SUBJECT: MEETING WITH MARK II OWNERS GROUP TO DISCUSS THE STAFF'S
MARK II CONTAINMENT ACCEPTANCE CRITERIA - NOVEMBER 14, 1978

NRC LEAD PLANT ACCEPTANCE CRITERIA REVIEW

NOVEMBER 1978 - SNPS APPLICATION

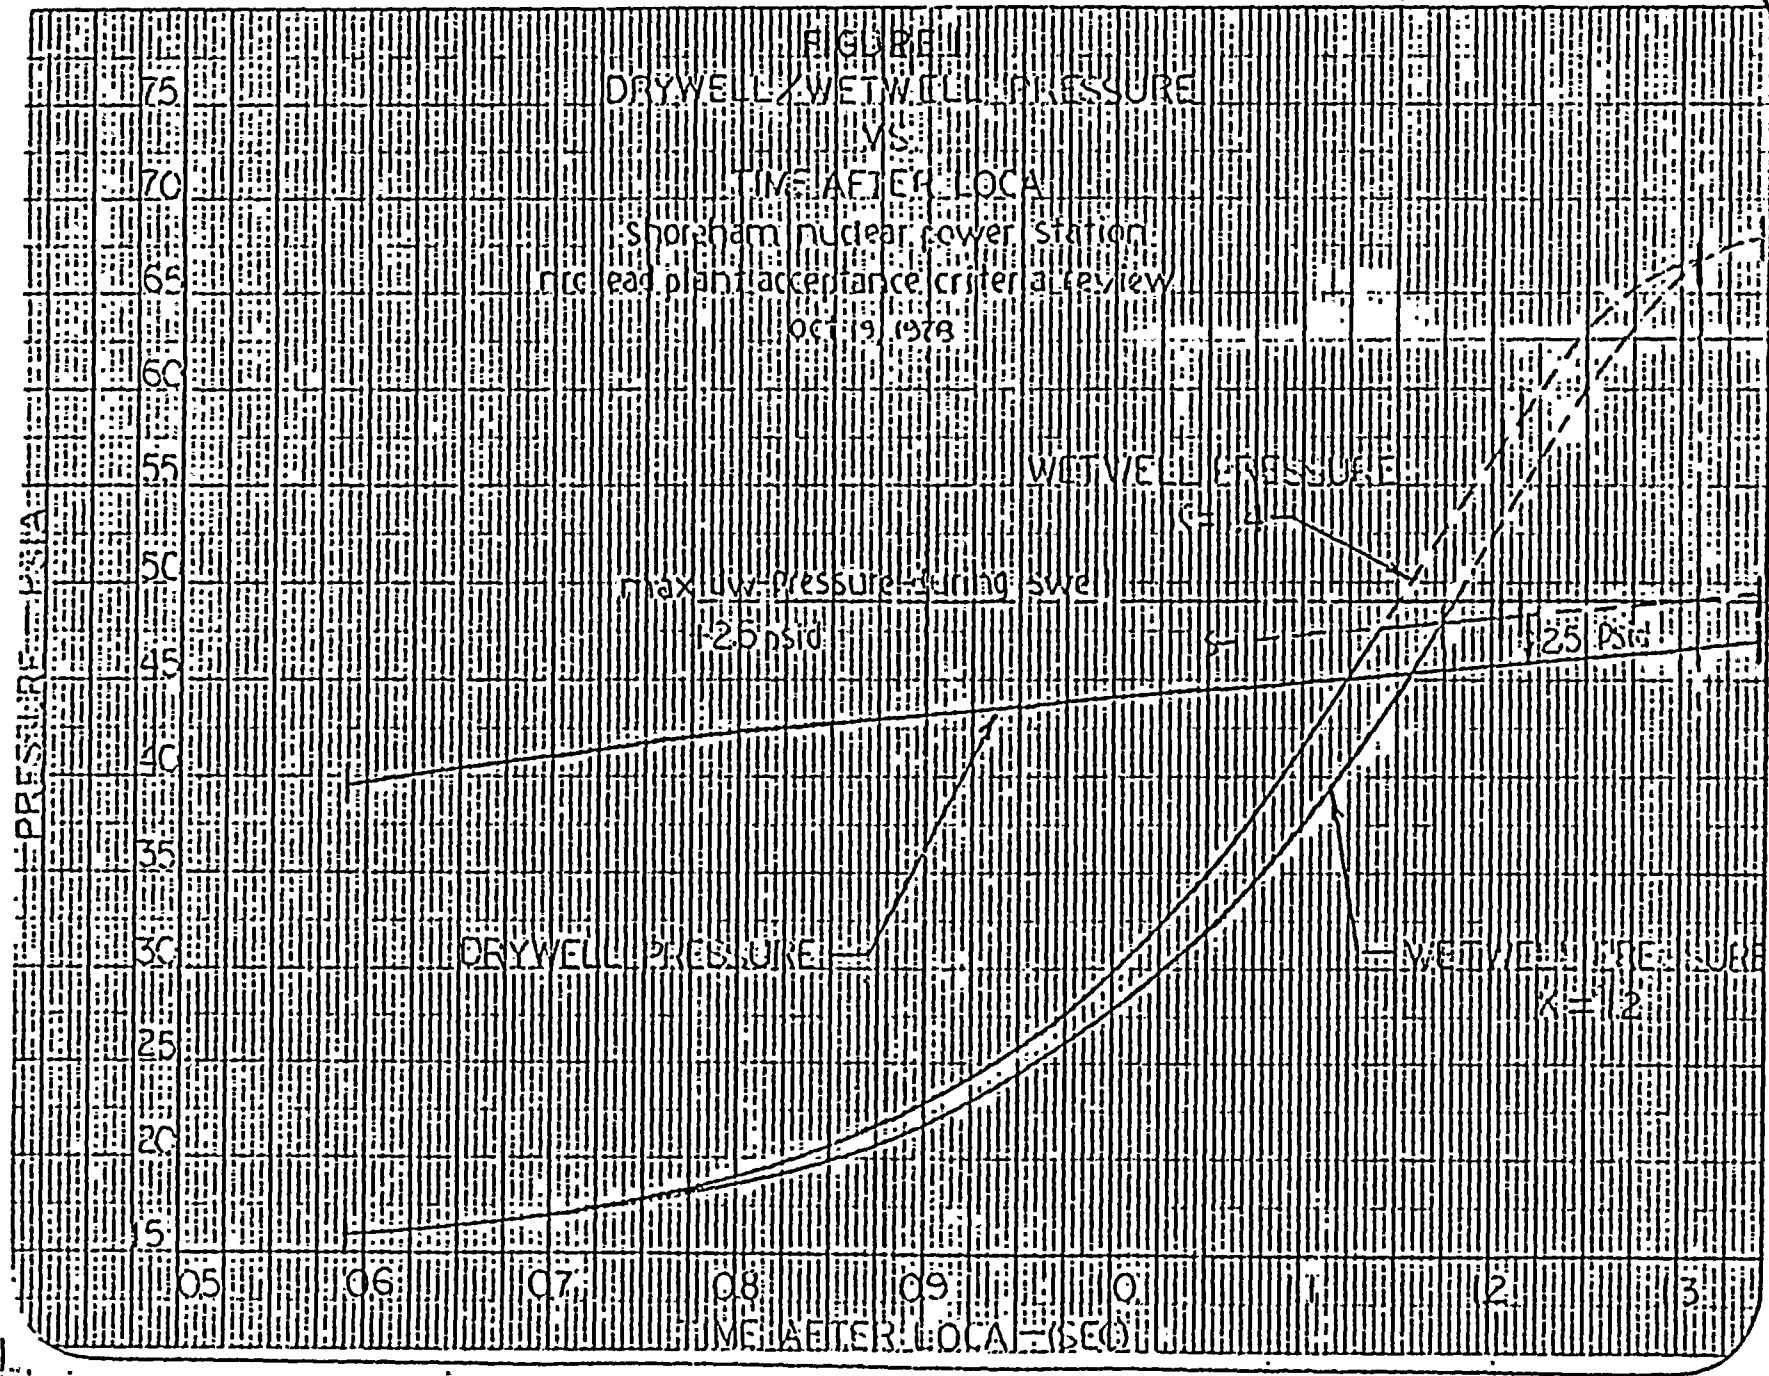
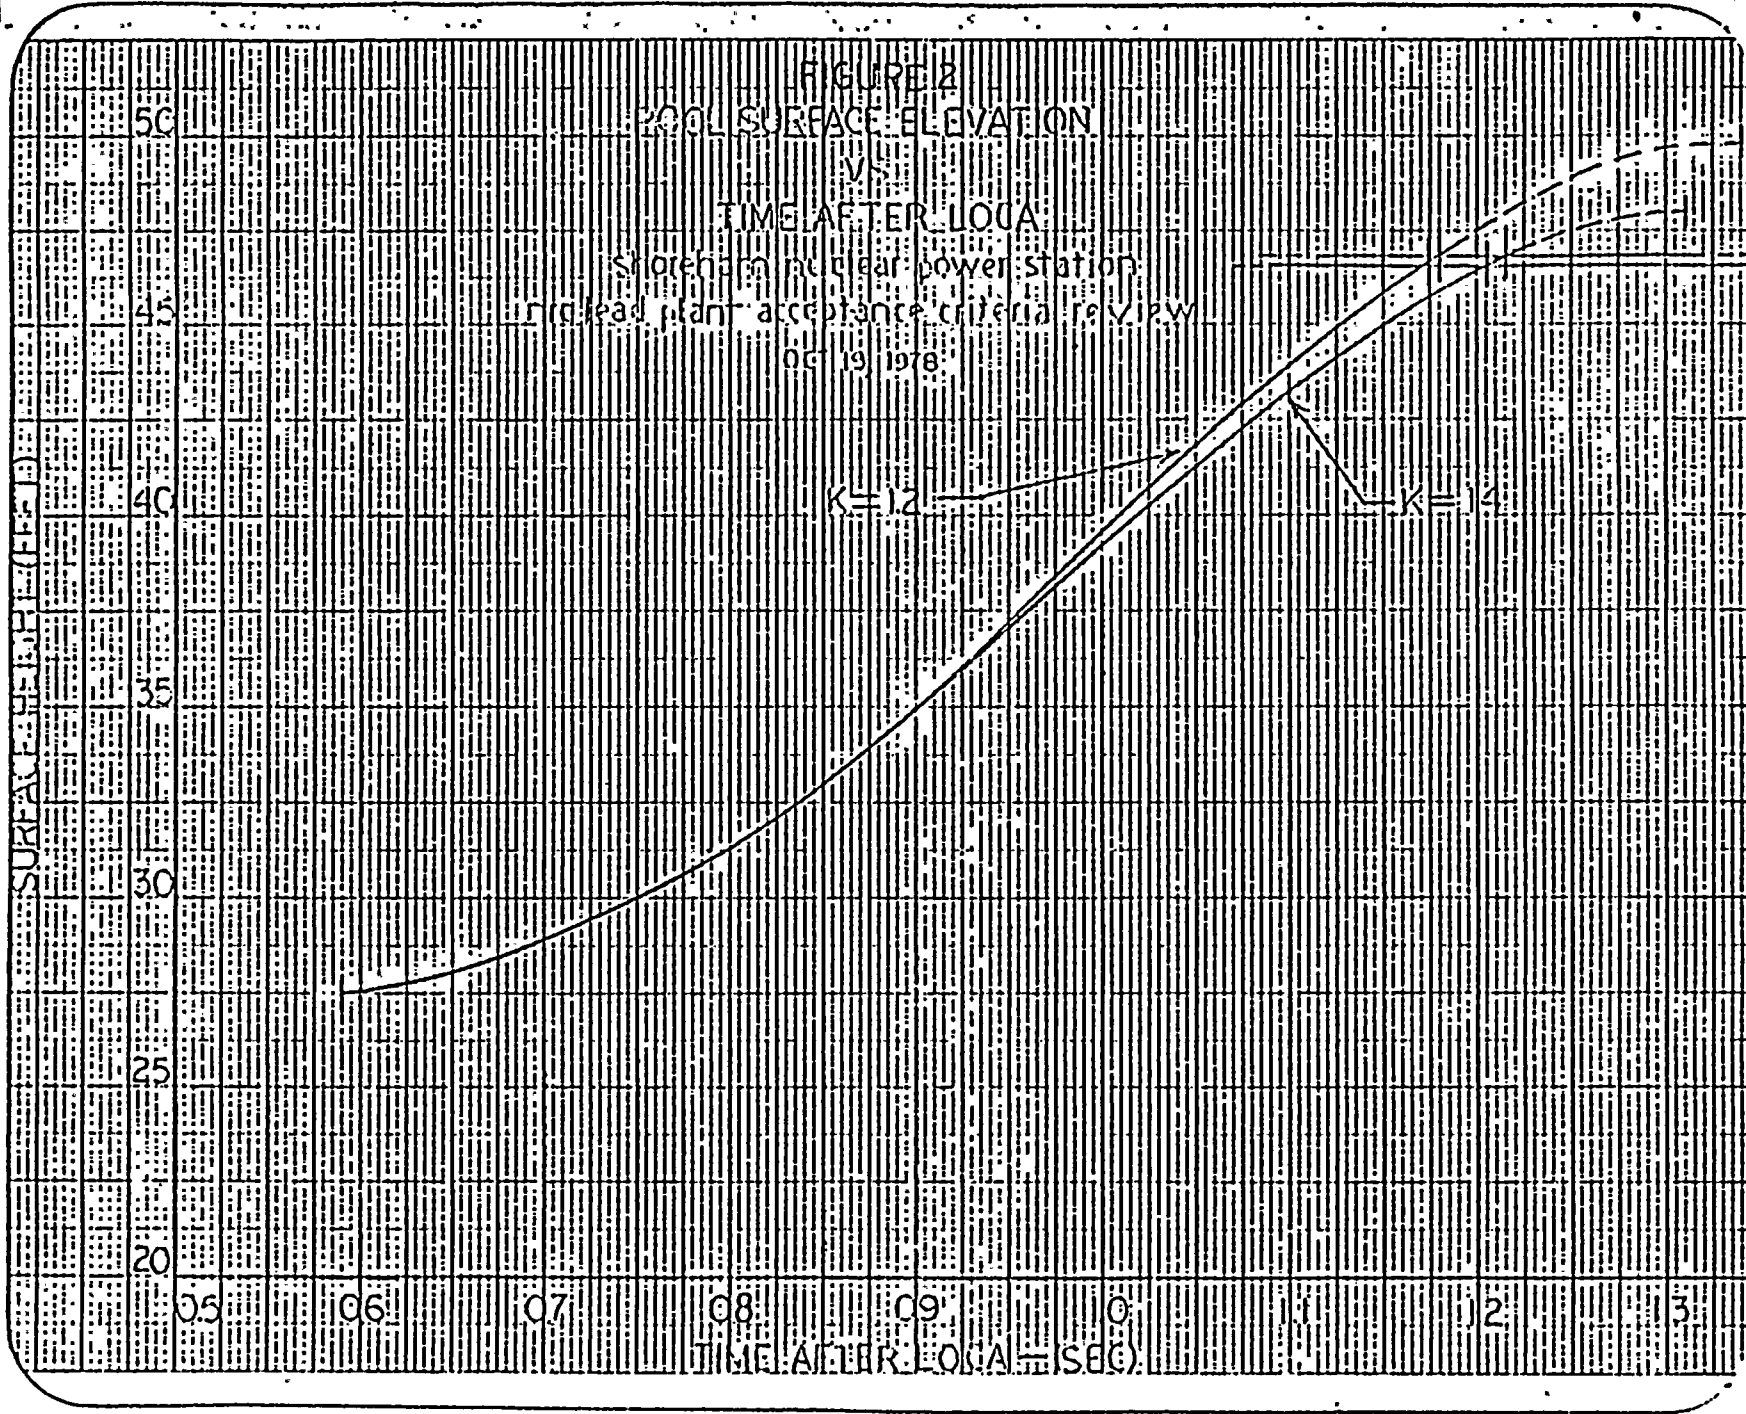
Above method used by SNPS - alternate method is to run PSAM with $k = 1.2$ and obtain maximum swell height directly. Both approaches shown for comparison in Figs. 1 and 2.

FIGURE 13 . COMPARISON OF 4T AND SHOREHAM DRYWELL PRESSURE RESPONSE TO THE DBA LOCA

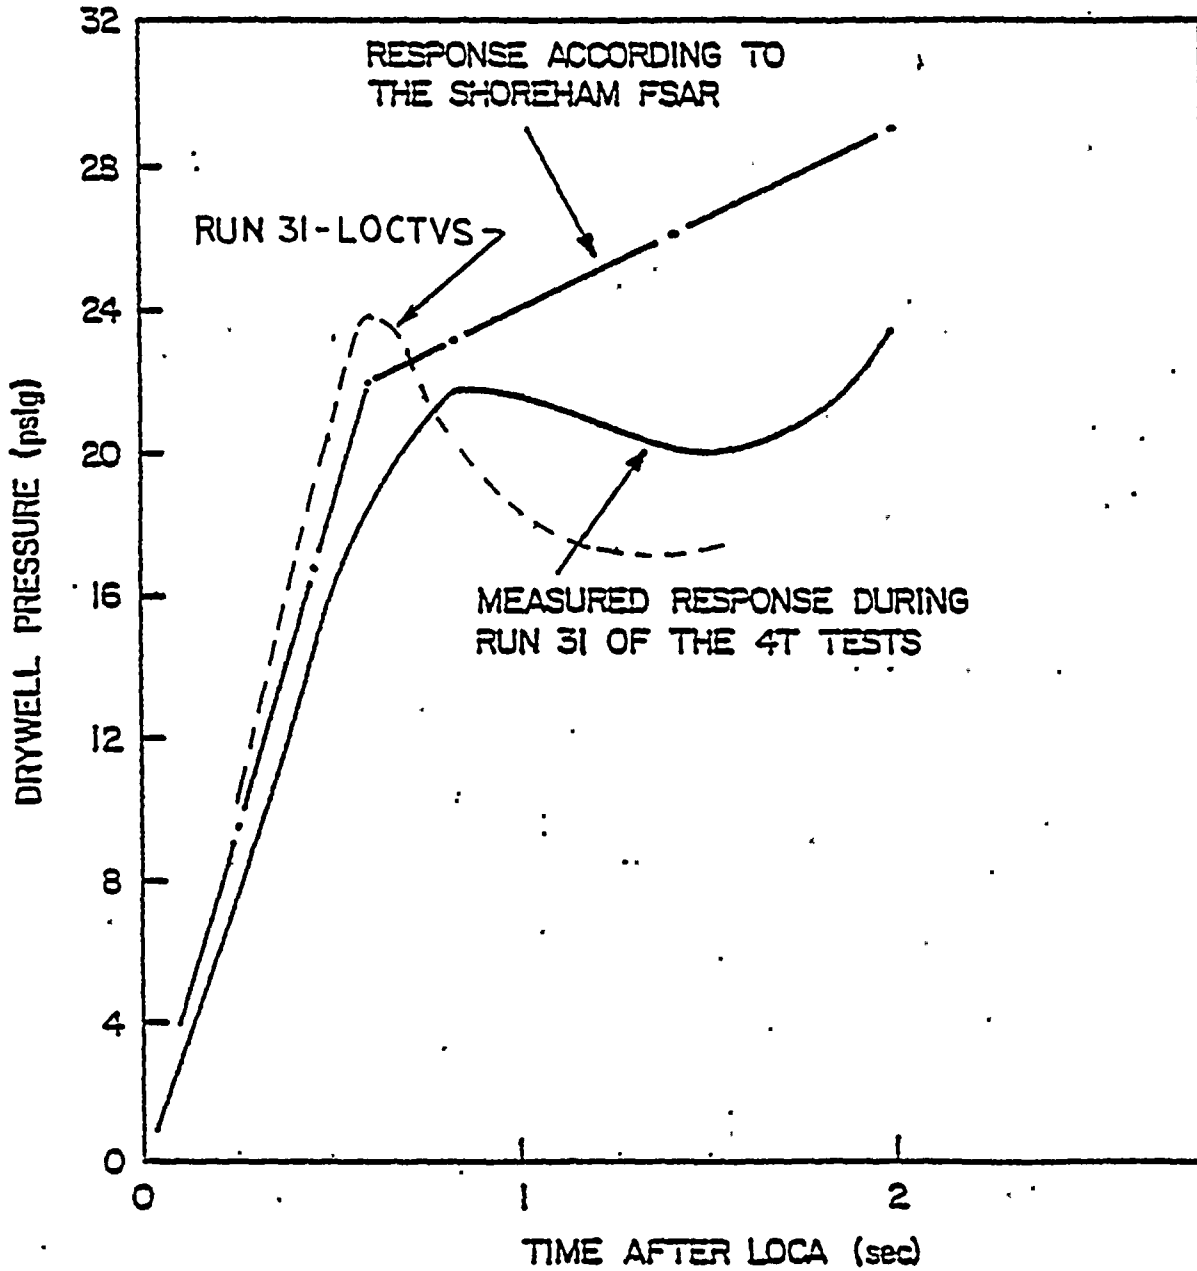
1. Refer to Fig. 13 (based on Fig. III-1 of Attachment 1 to NRC Lead Plant Acceptance Criteria) - SNPS drywell pressure history is somewhat greater than 4T run 31, either measured or calculated. Therefore, more conservatism expected in the application of "020.68 method" to SNPS than to 4T run 31.
2. Preliminary review of EPRI single cell results indicate single cell conservative compared to multivent. All other things equal, 4T will overpredict SNPS.
3. $K = 1.2$ more likely in 4T than in SNPS due to greater likelihood of significant heat transfer during swell. Again 4T will overpredict SNPS.
4. DBA for SNPS is liquid break - liquid breaks (Phase II, runs 36 and 37) expected to show even greater conservatism in application of "020.68 method." Additional information will be provided.
